November 23rd, 2020

ADDENDUM NO. 1

PROJECT: CITY OF DURHAM SOLID WASTE MANAGEMENT SCALE HOUSE & BREAKROOM
DURHAM, NC

N.I.C. **4 VEHICULAR GATE**
SCALE: 1/4"=1'-0"

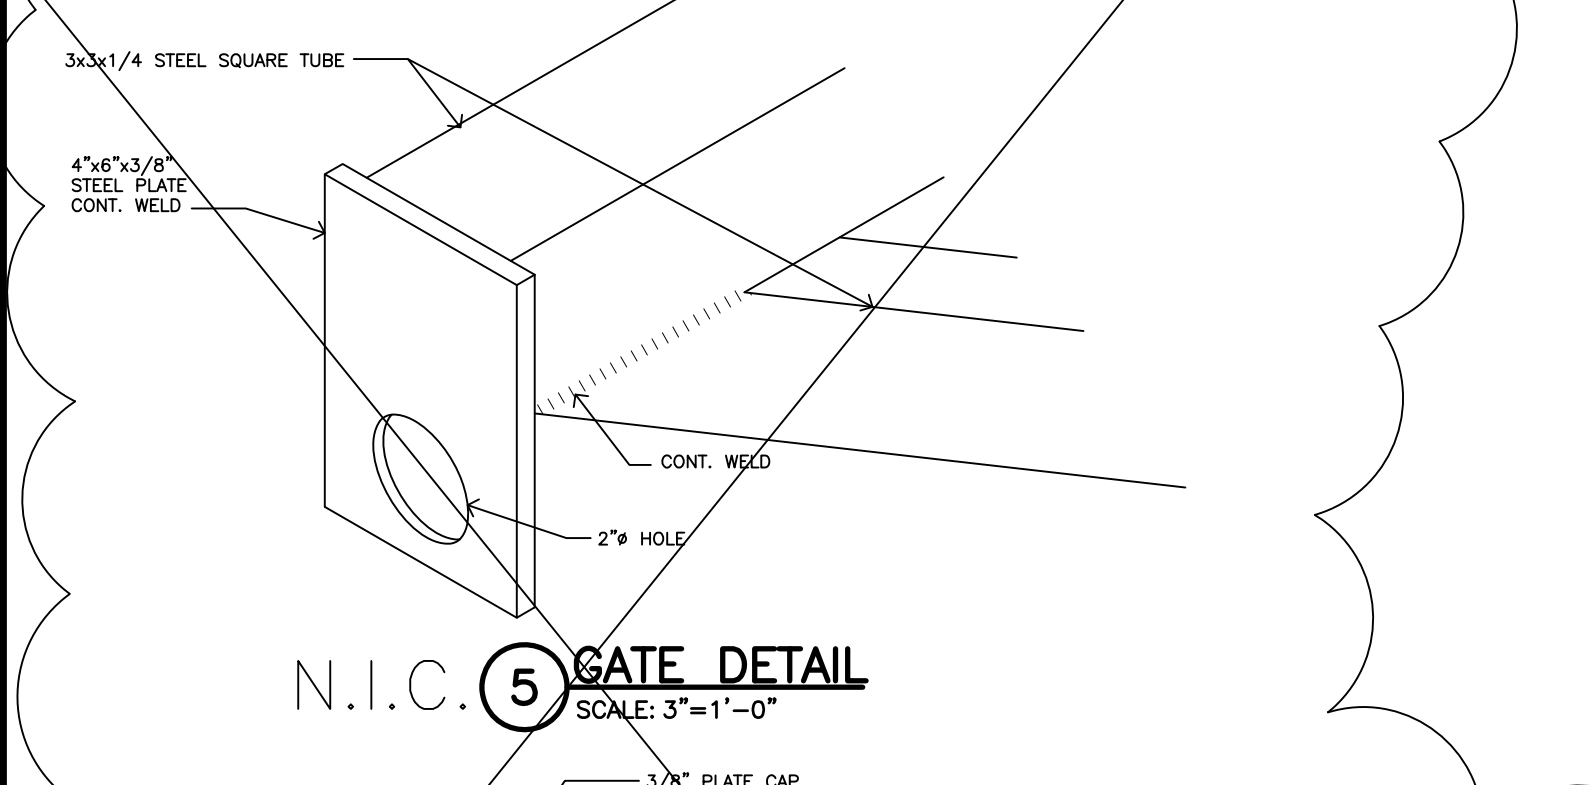
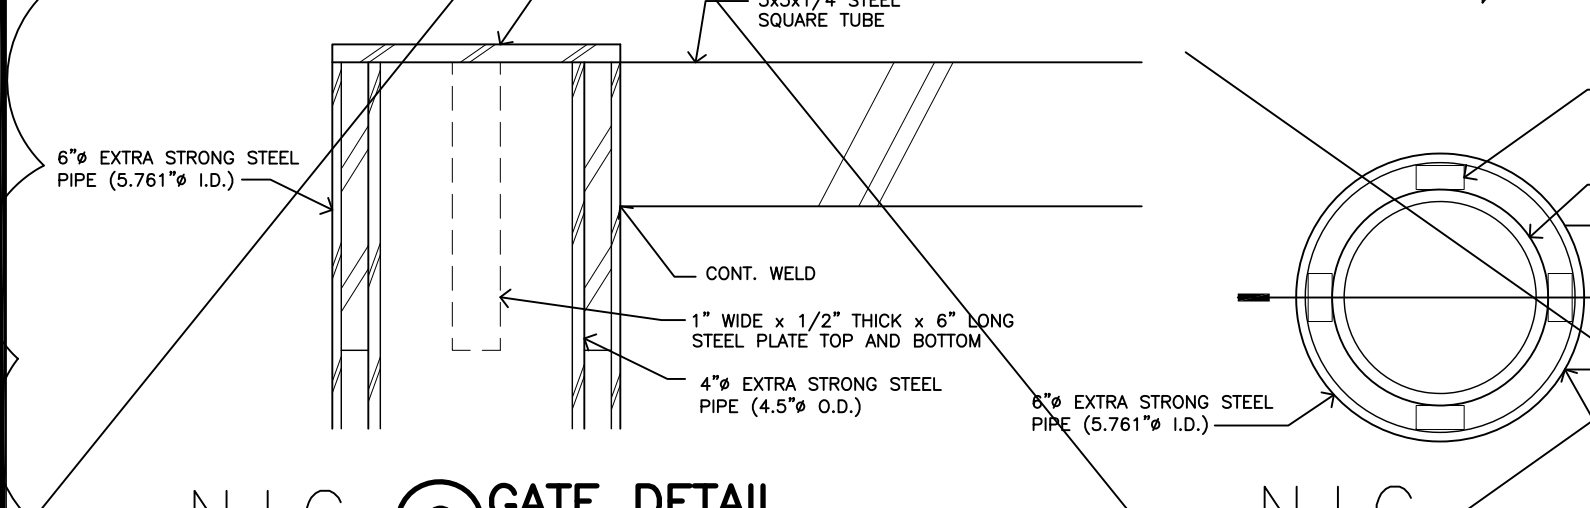
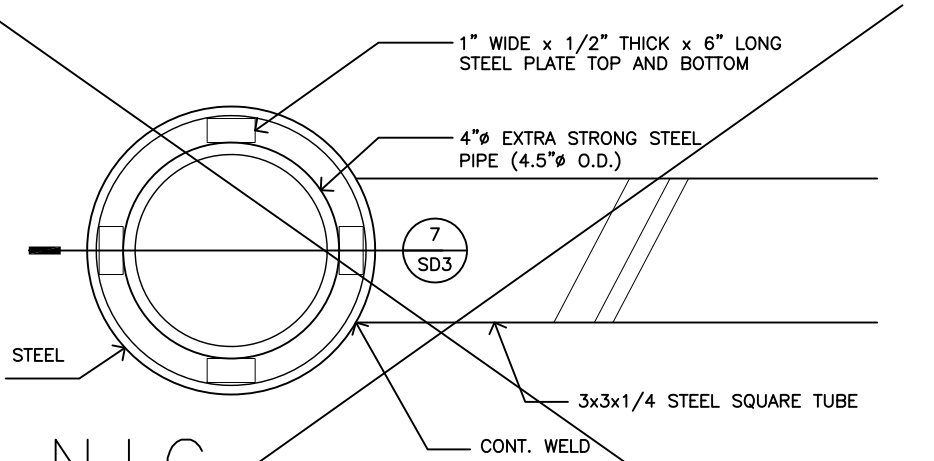
- b. In reviewing the plans for the Solid Waste Scale house I see a manual gate was added. I have searched the civil plans for where this gate is located and I only find one call out for a new gate. The gate detailed on A1 detail 4 measures 24ft in length. Where the gate is shown on the civil plans scales at 44 ft from post to post. Can you clarify where the gate is going if verify that detail 4 is correct?

- i. Answer: All concrete within the limits of disturbance is to be removed.
- g. The vehicular gate detail on sheet A1 shows a 24 foot wide gate and notes that 2 are required. The only gate shown on the drawings is on sheet C-2.0 and it is roughly 44’-6” wide. The specs also mentions two gates being 25’ wide. Please clarify what gates are needed specifically and in what locations.

- i. Answer: The gate details on A1 have been removed. See attached drawing sheet. Please see specification Section 111233: Parking Gates for gates for this project. The spec calls for (2) units each with a 25' long barrier arm. These will be located in the same location, but in lieu of, the swing gates shown on C-2.0. These gates are the gates that will be priced as Alternate G-3 on the bid documents. There is an "s" missing on the bid proposal form at the end of "gate" and "foundation" in the description of Alternate G-3. The alternate shall be priced for (2) gates and (2) foundations.

- i. Answer: See answer to “b” above.
- h. One of the modular manufacturers asked: Would vinyl covered wall covering in lieu of painted walls be accepted? They state that they are more common in modular buildings.
